City Council Report

City Council Meeting: February 14, 2012
Agenda Item: 4A

Subject: Colorado Esplanade Design Progress and Recommended Roadway Configuration

TABLE 1 – PLANTING AND TREE PALETTE

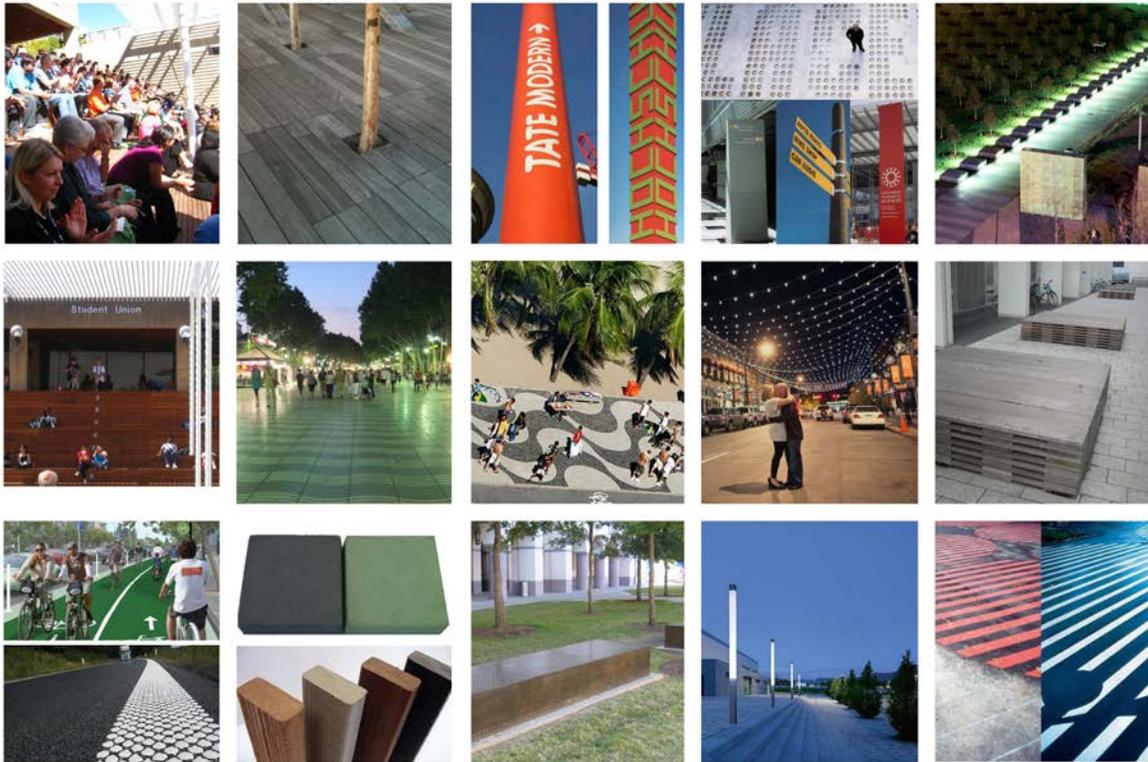
- The character of the planting should be formal, not random. Colorado trees should be a strong, planted identity that moves down the street and unifies it, without creating dense shade
- Trees should contribute to the creation of a unique space
- Strong support for trees to frame view of the Pier sign
- Trees and plants should be enduring/bulletproof
- Generally positive about use of some Palms – type must be appropriate and not overused
- Some interest in diversity of planting – use of materials at ground level in addition to signature trees, and plant diversity as contributor to “City as Arboretum”
- Strong support for Ficus trees grove in Gateway – playful and good use of existing material.

- Trees are the most important part of the scheme
- Concerned about street trees blocking Sears sculpture; trees should accentuate buildings
- Expo Plaza needs canopy trees to provide shade

- Make sure there is no tree litter in the bike lanes. Also, remove trees at corners where there are right-hand turns. Such trees create visibility problems for bicyclists and vehicles.

- Love the Ficus trees in the Gateway Plaza – must thoroughly check trees prior to move to make sure root mass can support tree or identify need for providing supports until rooted.

COLORADO AVENUE ESPLANADE | PAVING AND SITE ELEMENTS

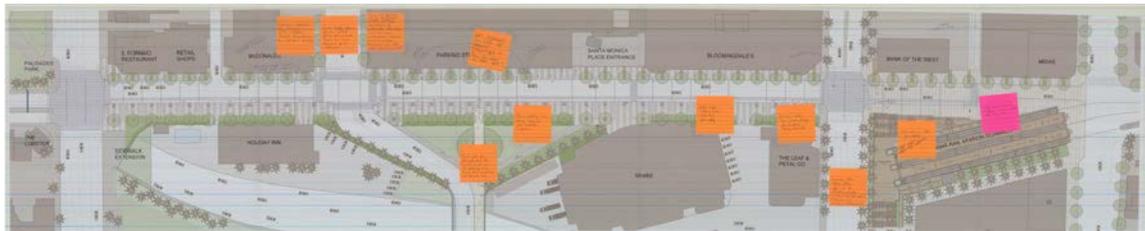
- Almost unanimous support for signature lighting, and lighting identified as a critical element for safety and night-time design experience. Consider trees and night-sky in lighting choice and placement
- Strong interest in playful art elements, and using art as an opportunity to create a sense of place
- Support for integrating vertical elements or pavement features into wayfinding or timeline

- We need a “Bean” art element here
- Coney Island vs. Time Square—why symmetrical trees?
- Look at sidewalks around Ficus Trees (they need repair)
- Look carefully at string lights; similar concerns at Palisades Garden Walk regarding lighting levels and the appearance of metal poles during day
- Safety concern regarding seating at the Station Plaza
- Treescape—acclimation/arborist commitment and City Staff review is important

- Interest in seeing lights arc-shaped like pier gateway; not so rigid/straight; consider linear lights on Colorado east-west to reinforce views down to the pier

- At Station Plaza, seating/stadium could be curved, not just straight/hard edged
- Love bringing Pier/wood timbers up to station!
- Will porcelain tile in wood grain pattern work for paving?

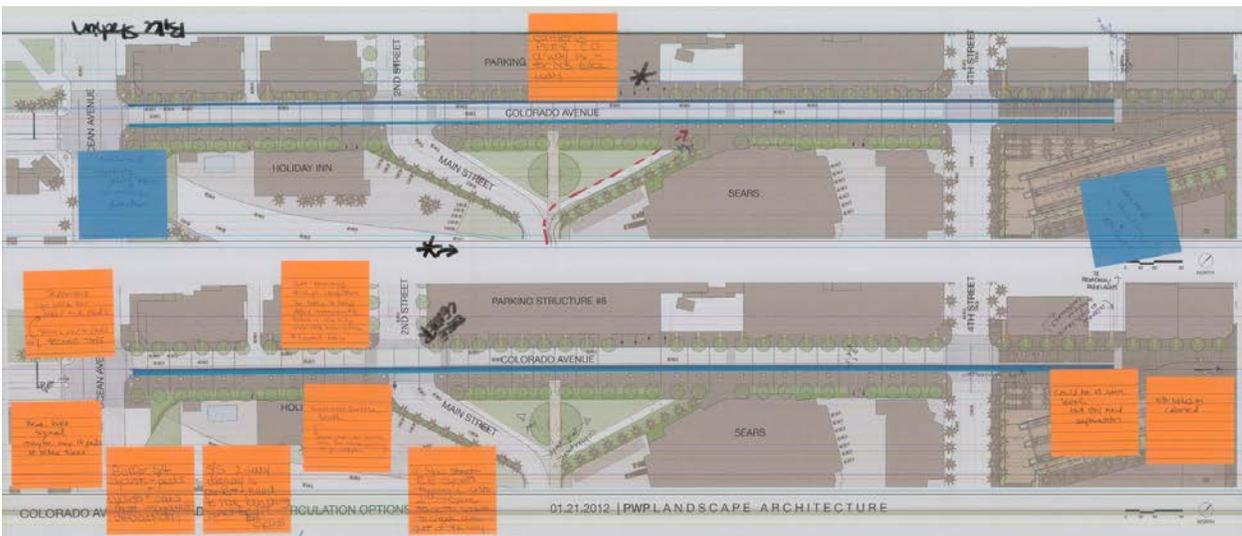
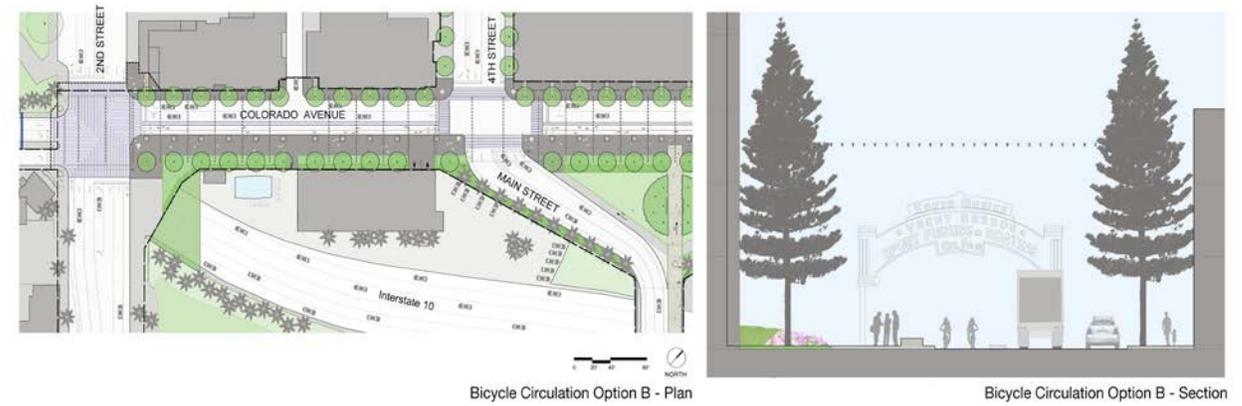
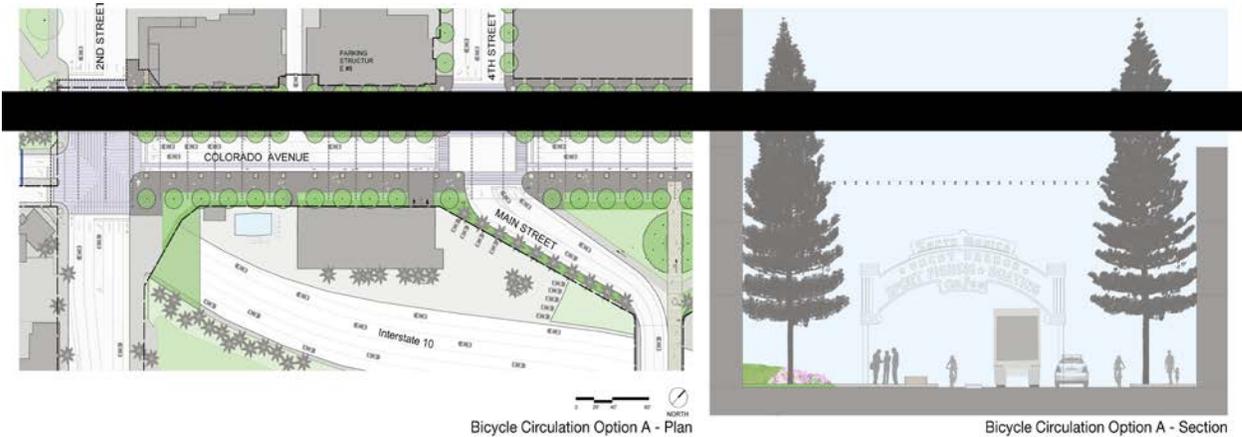
- Support for differentiated paving
- Wide support for special lighting
- Focused lighting to balance the night sky
- A range of ideas about light forms between support for string lights and preference for a more sculptural light fixture

- Shield night sky from lights – otherwise I like the lights
- Lighting very important – especially for women at night
- Any lit fountains?
- The overhead lights feel cheap. They create a carnival environment that is much more appropriate for Venice Beach. SM needs more creative and sophisticated lighting. It interrupts view down the Esplanade

- Light strings are ugly and add to light pollution upward. How about something like Pico lighting?
- Love light tubes at LAX. Something like that could make this a special place

- String lights have been done so much already. Why can’t we have a sculpture street lighting similar to Pico Blvd on a bigger scale. Fabricate in the USA

TABLE 3 - BIKES

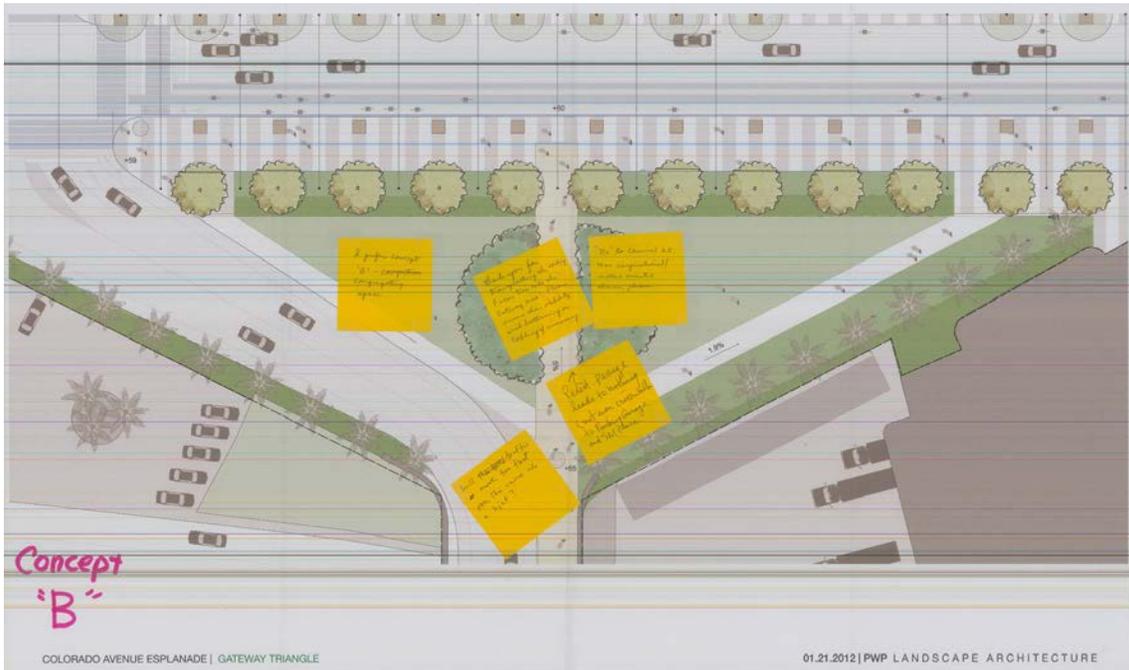
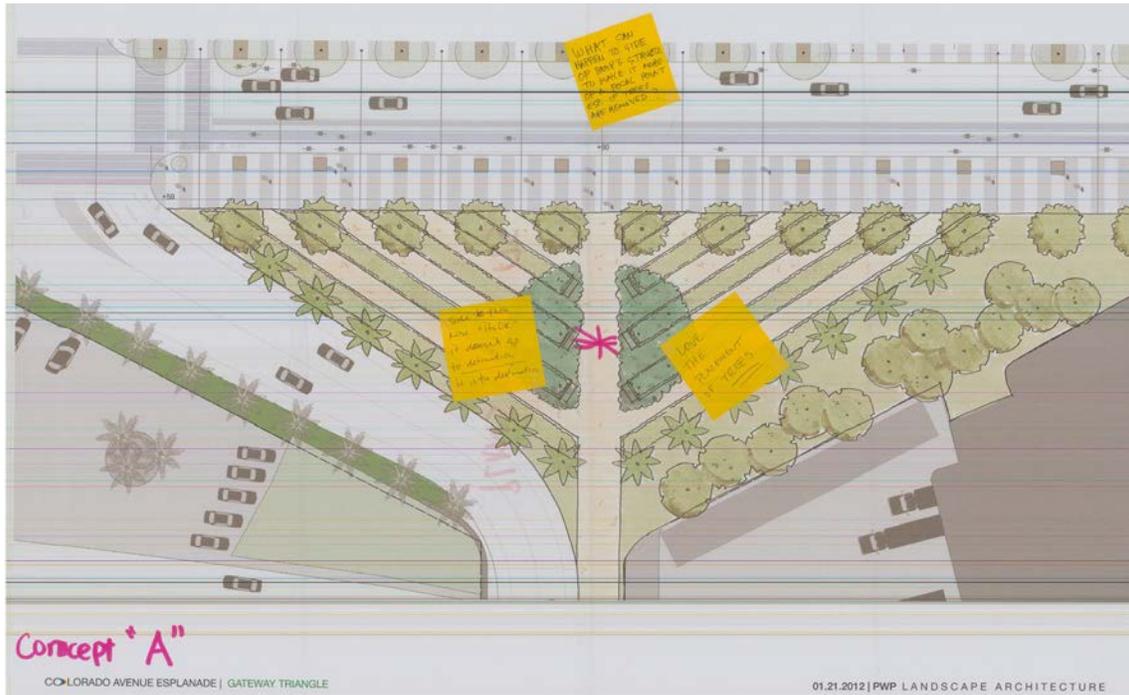
- Almost unanimous support for the cycle track on the south side of the street, with the intersection details getting refined and worked out
- Provide a clear separation between bikes and pedestrians, including keeping bikes on the street level
- Very strong support to make bicycle connections between Pier and Station, including finding a direct connection to the Beach Bike Path
- General support for making Downtown connections, including at 2nd Street and 4th Court

- Separate bike path from other paths
- Seems like bike facility is well thought out
- Bikes should obey lights and respect pedestrians
- Split bike lanes
- Like the combined cycle track – minimum 14'. Grade separate and carefully design signage and way finding
- Including signage about where bikes are prohibited
- Bikes need their own lane with curbs – separated from peds and cars
- Provide elevated buffer toward pedestrian; widen cycle track – minimum 14'; carefully design intersections and transitions
- Prefer cycle track with raised curb on both sides; also provide sharrows for westbound on-road cyclists
- Carefully design intersections; include bike racks in plaza

- Separate bikes and peds
- Prefer cycle track
- Cycle track solves most of the issues, and removed driveway conflicts at parking structures
- Provide safe connection Ocean-Colorado; improve north-south routes
- Like the bike plan; not sure about one lane for east and west travel
- Higher buffer between pedestrians and bikes
- Don't stripe ped and auto areas the same – too confusing
